SUBSURFACE WASTEWATER DISPOSAL SYSTEM APPLICATION

Town Or Plantation	AUGUSTA
Street Subdivision Lot #	BOLTON HILL RD.

Last: WEEKS First: JEFFREY

SUBSURFACE WASTEWATER DISPOSAL PLAN

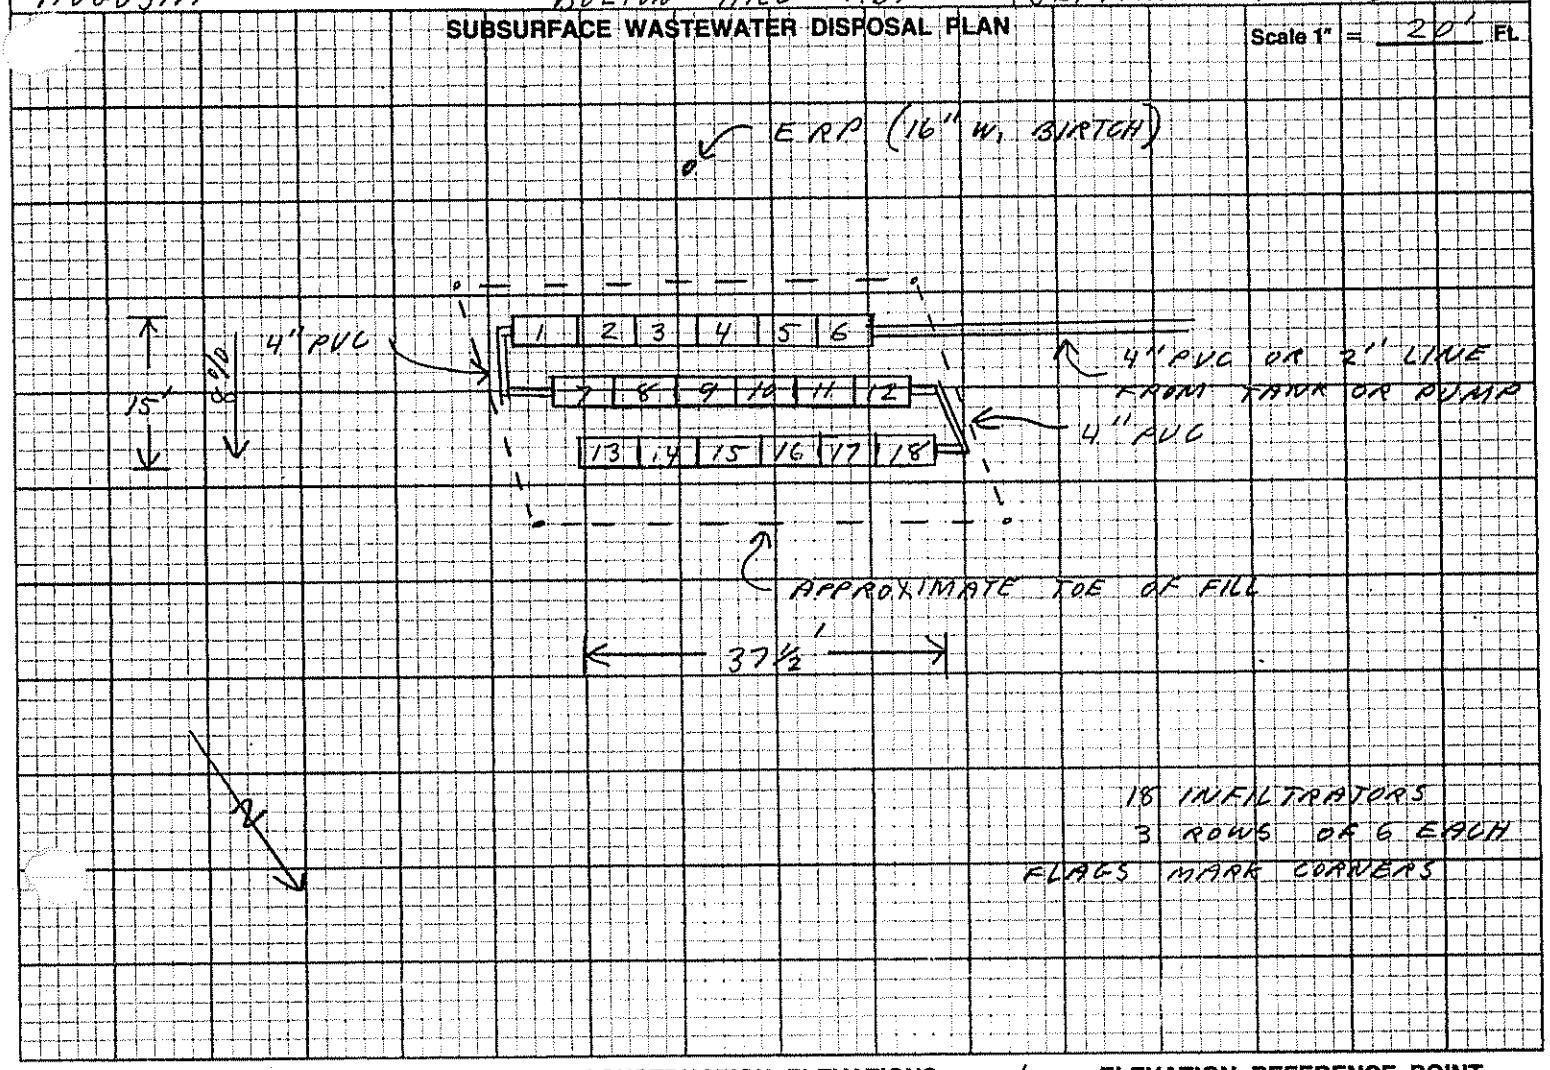
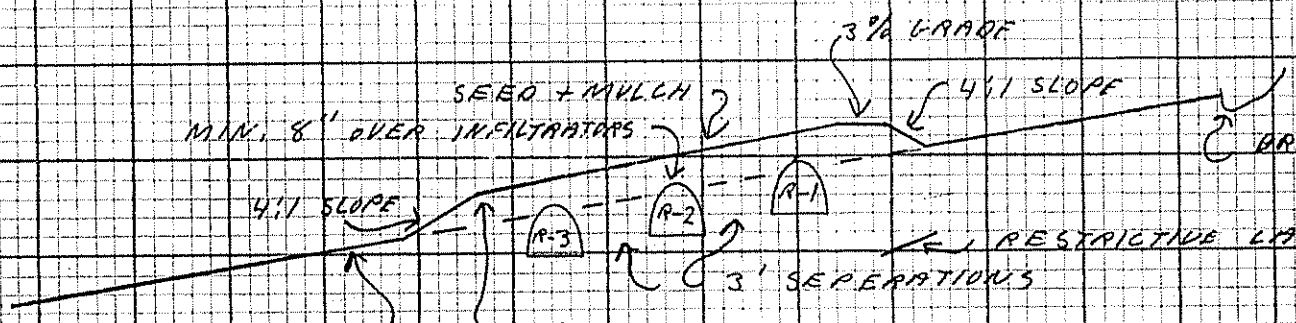
Gary Fuller and I met with Mr. Weeks and his contractor at this site. The elevation that I shot are indicated next to the specified, separation is now correct, last Friday both were incorrect elevation & separation.

I made Mr. Weeks aware of the clay spots in the fill being used and the concerns I had. I explained that all clay should be removed.

Reference Elevation is 0'
Bottom of Disposal Area ~~31~~ R-1 -53"
Top of Distribution Lines or Chambers R-1 -38"

R-2	-59"	-44" ~~-38~~
R-3	-65"	-50" ~~-45~~
